Record of Decision

Ley Creek PCB Dredgings Site
Salina (T), Onondaga County
Site Number 7-34-044

March 1997

Ley Creek PCB Dredgings Site
Proposed Remedial Action Plan
Salina(T),Onondaga County
Site No. 7-34-044

FIGURE 2: PROPOSED EXCAVATION AND CONSOLIDATION AREAS

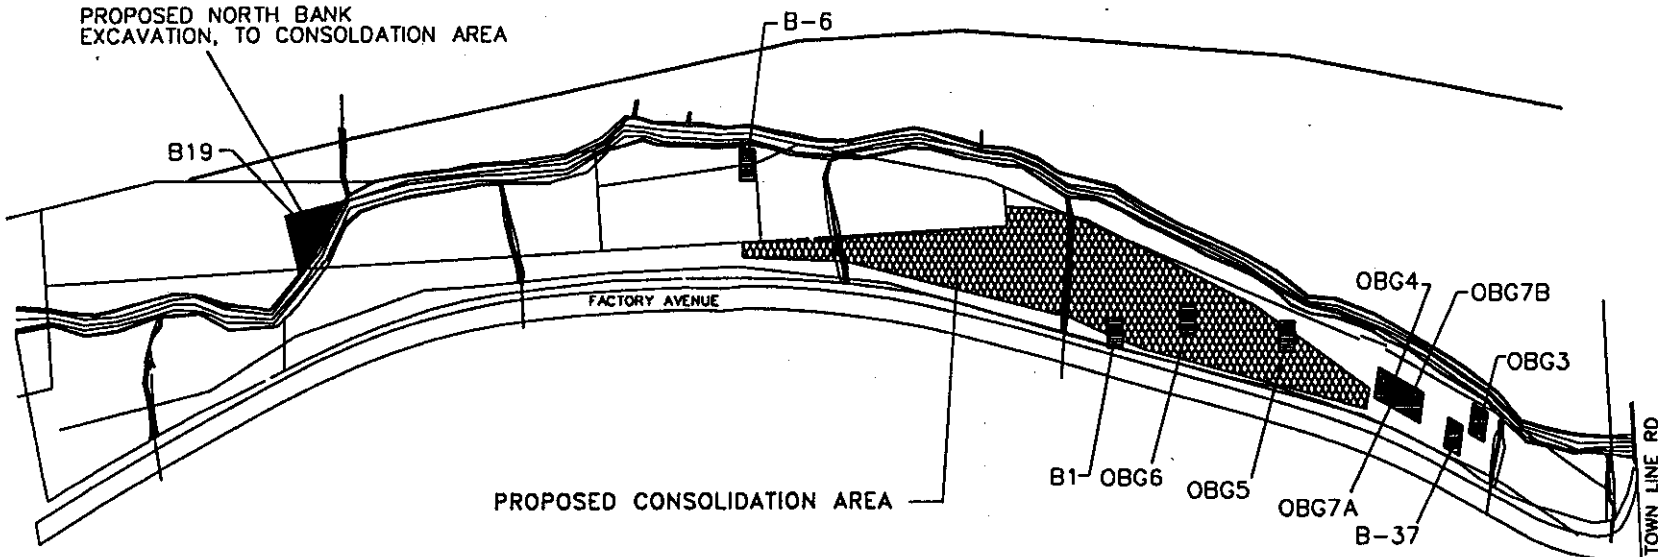
COMMENT 14: Alternative 8 contemplates, in part, removal and off-site disposal of soil taken from certain "hot spot" areas (Final Feasibility Study, dated October 1996, "Final FS", p 59). However, the "hot spot" areas may not be the only areas of significant PCB contamination.

According to the map entitled Proposed Excavation and Consolidation Areas (Final FS, Figure 10), none of the "hot spot" areas to be excavated appear to be located on the Ryacuss parcel. However, the closest excavation point seems to be less than 200 feet away (Id.). The maps containing the soil boring locations included with the appendices of the Remedial Investigation Report ("RI") and the Final FS do not delineate the boundary of the Ryacuss parcel making it difficult to determine soil boring locations in relation to the Ryacuss property boundary.

It is possible that either or both soil borings designated as B7 and BB lie within the Ryacuss property boundary (Final FS, Figure 2).

Because there is no pattern of distribution of the PCBs throughout the Study Area and PCBs are present throughout the area in question at levels requiring remediation (see, PRAP, p 8), given the available data it should be assumed for the purposes of remediation that elevated levels of PCBs exist within the soils of the Ryacuss parcel. Even if there are no "hot spots", there is contaminated soil that, if left behind, has the potential to cause health or environmental problems. The soil from the Ryacuss parcel ought to be excavated and removed for off-site disposal.

RESPONSE 14: The location of all soil borings have been reviewed relative to the Ryacuss parcel. After the reviewing the RI data in response to this comment it was identified that the location identified in the Feasibility Study and the PRAP as boring location B-6 was in fact boring location B-6M. The actual location of B-6 is near the northeast corner of the Ryacuss parcel. The correct location of boring B-6 is shown on a revised Figure 2 in the ROD.

Ryacuss parcel, Boring B-6, where sampling identified levels of PCBs in excess of 50 ppm. This area will be excavated to remove this material, however, PCBs will remain on the balance of the parcel at concentrations less than 50 ppm. The soil cover, included in the selected remedy, will cover the entire parcel, mitigating any identified human health and environmental exposures, which may result from the contaminants remaining at the site. While the selected remedy will be protective of human health and the environment Syracuse China/Pfaltzgraff, as the property owner, is free to attempt to negotiate with GM other reasonable considerations as a condition of access to their property.
